BRITISH GLIDING ASSOCIATION

BGA TECHNICAL COMMITTEE

TECHNICAL NEWSHEET TNS 5/6/94

PART 1 Airworthiness "AGGRO". Please add to the BGA 1994 Red Pages.

FIGURE 1
LOCATION OF FLUSH SKIN JOINTS

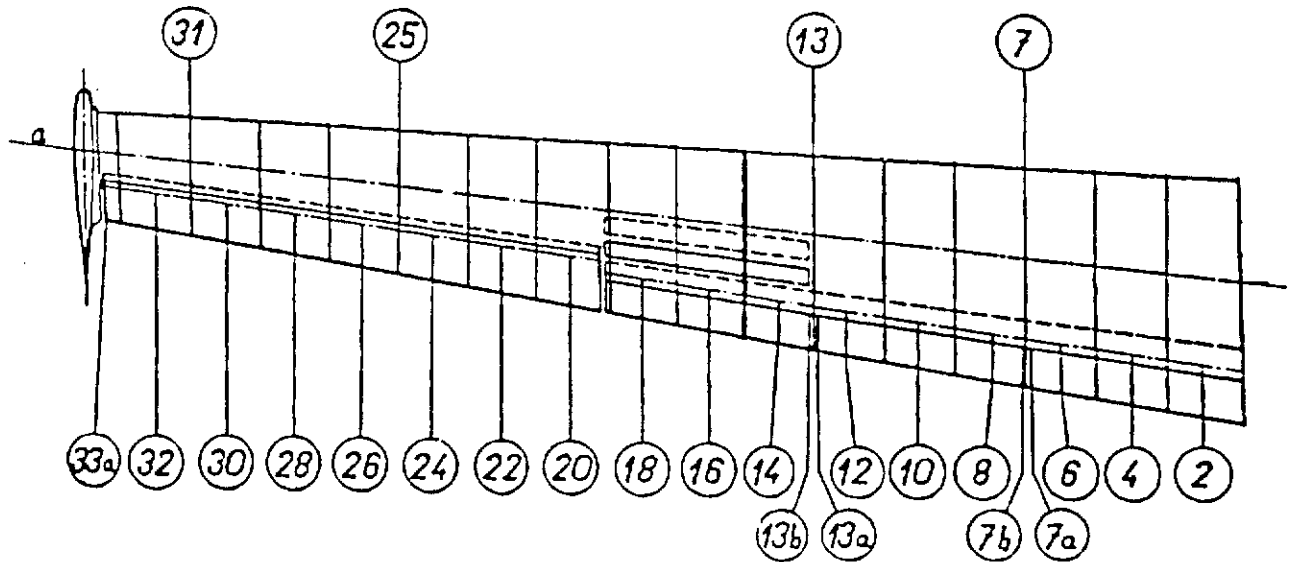
SUBJECT: Cracking of wing Ribs.

BACKGROUND: During a routine inspection cracking was noted in the flange of the wing rib and the stiffeners at the flush skin joint at station 13.

Further inspection of other Blaniks showed that 7 out of 9 inspected gliders had cracking of some degree at this station. Inspection of the ribs at other stations with flush skin joints also showed minor cracking at station 7.

The Flush Joints at Stations 25 and 31 are the same detail design as stations 7 and 13 and so are possible cracking sites.

The extent of the cracking was such that the worst wing was very near to failure.

- 1.3. Blaniks (L13). Cracking of Wing Ribs at Station 13 - Inboard of Speed Brakes. Sketch from GFA (Australia) attached for action.
- 1.4. Valentin TAIFUN CRACKS in FLAP LEVER - LBA AD 94-114 (herewith) requires ACTION.

KESTREL RUDDER DRIVE

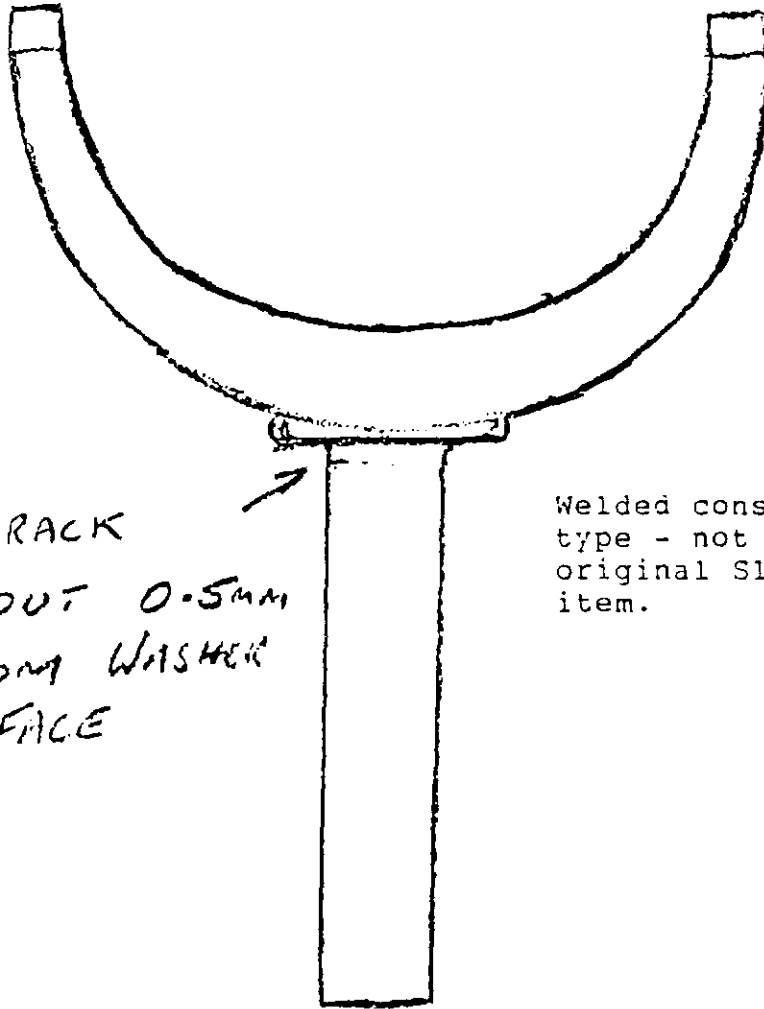
- 1.5. M-T Propellers Erosion Strips - not secured. LBA AD/94-098 (herewith) requires ACTION. (Fitted to some SF25E's, Dimona's etc).
- 1.6. Kestrel Rudder Drives continue to crack at weld. Sketch from Stu Hoy - herewith.

CRACK
ABOUT 0.5MM
FROM WASHER
FACE

Welded construction
type - not the
original Slingsby
item.
